Technical Guidance Committee Meeting

Minutes

Wednesday, July 22, 2015

Department of Environmental Quality
1410 North Hilton
Boise, Idaho

[Figure 4-2. Cross-sectional view of an above-grade capping fill trench.](#)

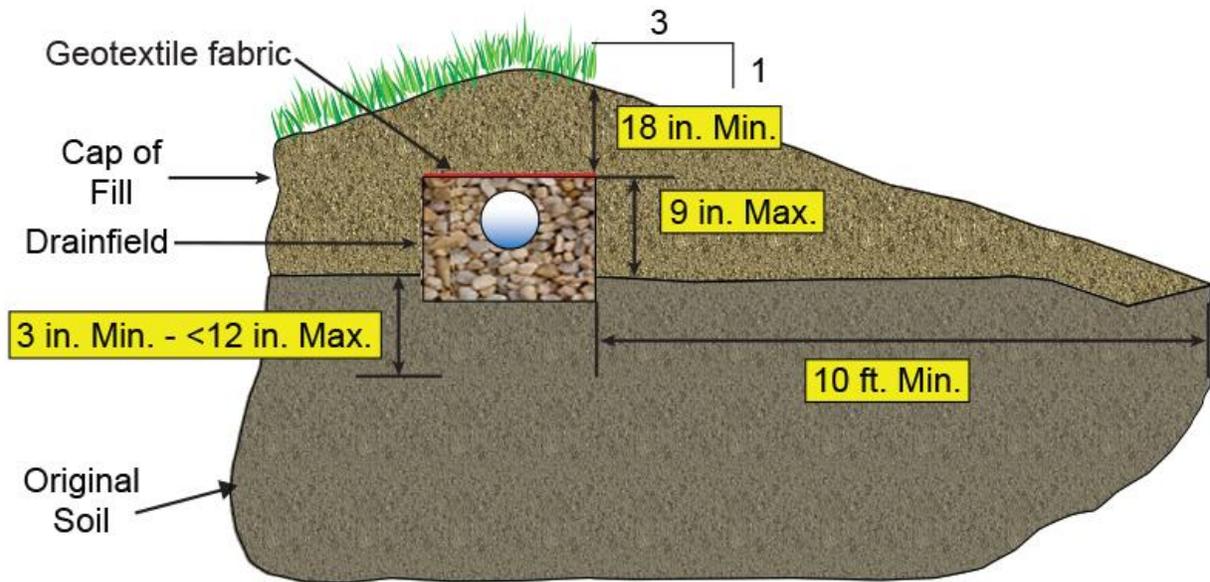
Mike Reno requested that a change be made to the construction requirements for the above-grade capping fill system that the soil cap must be constructed prior to system excavation when constructing with pipe and aggregate.

2. Site may not exceed 12% slope.
3. The soil cap ~~may~~[must](#) be constructed prior to system excavation but after natural soil scarification [when constructing with pipe and aggregate](#).

Figure 4-31. In-trench sand filter accessing suitable soils through an unsuitable soil layer.

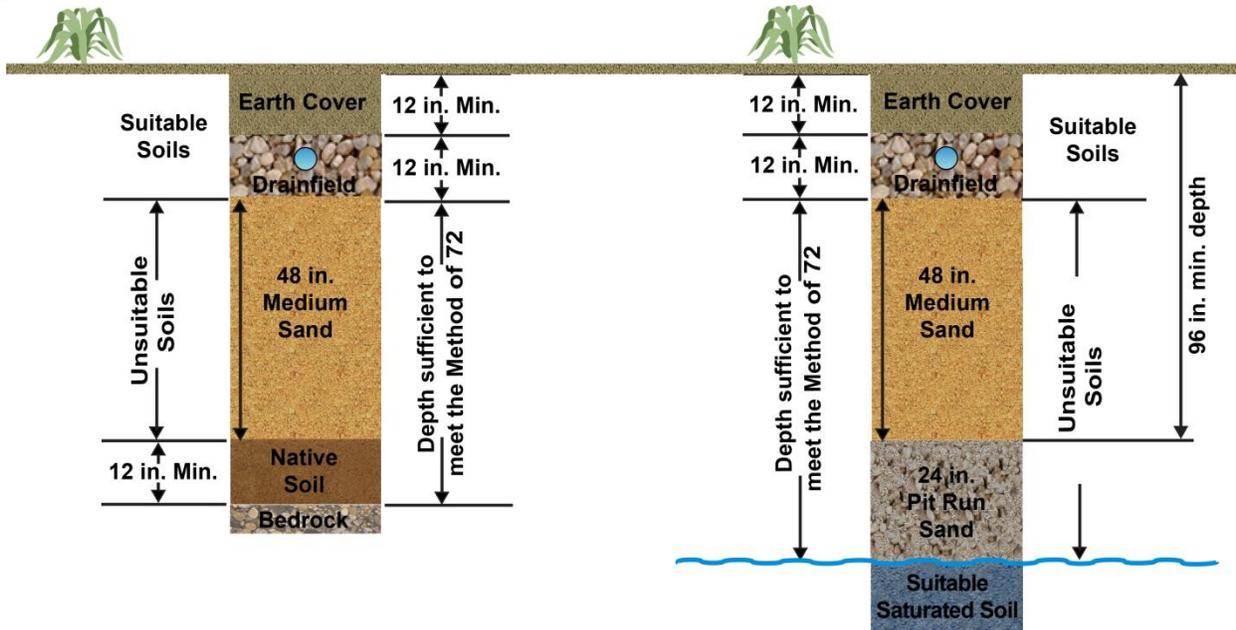
The committee held a discussion on the system equivalencies in relation to the system design. Tyler Fortunati stated that the standard in-trench sand filter depicted in figure 4-31 was consistent with the method of 72 and related standard system designs, the enveloped in-trench sand filter depicted in figure 4-32 was consistent with the method of 72 and related standard system designs, the enveloped in-trench sand filter depicted in figure 4-33 was consistent with separation distances for alternative pretreatment designs like the recirculating gravel filter, intermittent sand filter, etc. due to the requirement of pre-treatment preceding this drainfield design, and that the enveloped and pressurized in-trench sand filter shown in figure 4-34 was consistent with other pressurized filter designs like the intermittent sand filter and sand mound.

Figure 4-32. Standard enveloped in-trench sand filter for installation in coarse native soils (i.e., coarse or very coarse sand or gravel).

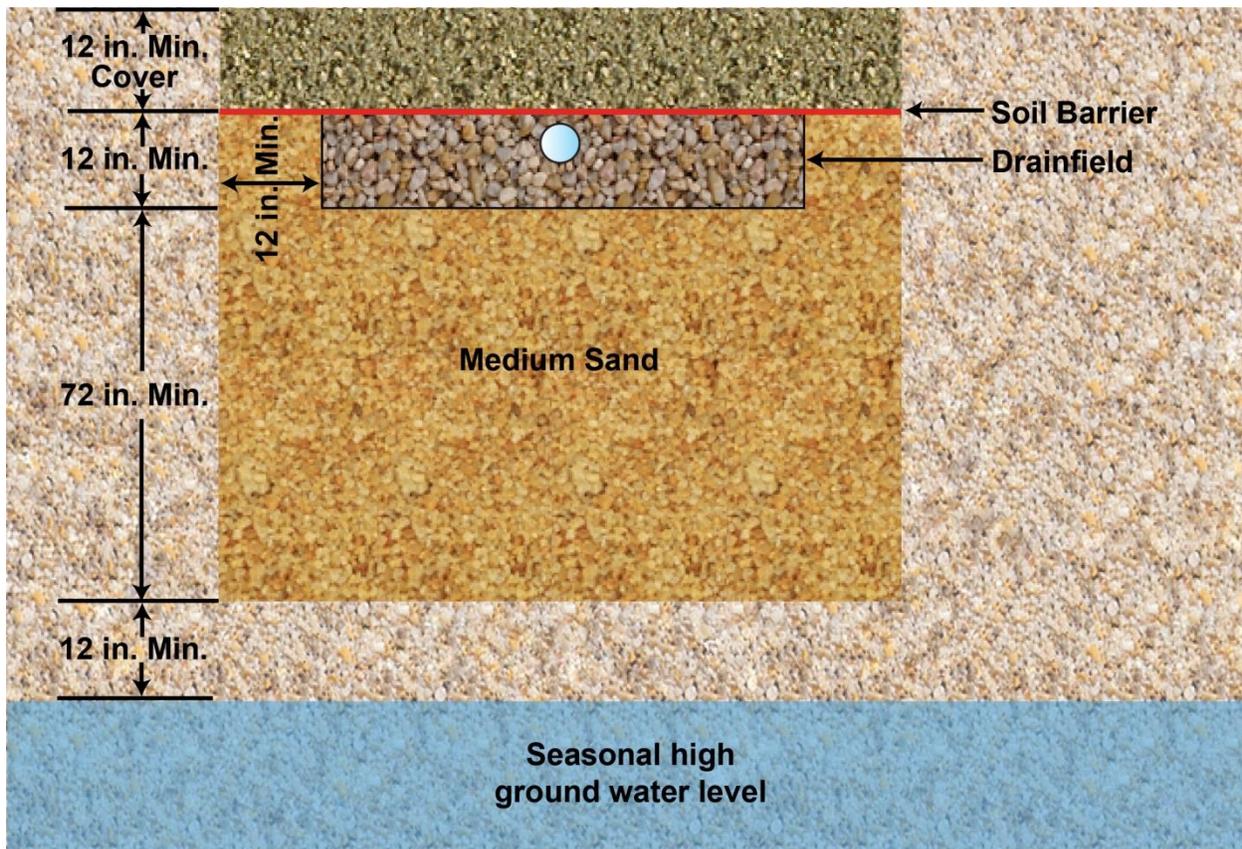
Dale Peck requested that a change be made to the enveloped in-trench sand filter designs for the application rate related to clay loam being less than the application rate for the clay loam instead of more than the application rate.

- 2) Unsuitable soils that have application rates less than clay loam as described in Table 2-9 are not suitable for installation of an enveloped in-trench sand filter.
- 3) The minimum depth of filter sand below the drainfield shall be 6 feet Figure 4-32.
- 4) The enveloped in-trench sand filter must maintain a minimum of 12 inches above any limiting layer from the bottom of the filter sand.
- 5) The drainfield shall be sized at 1.2 GPD/ft².
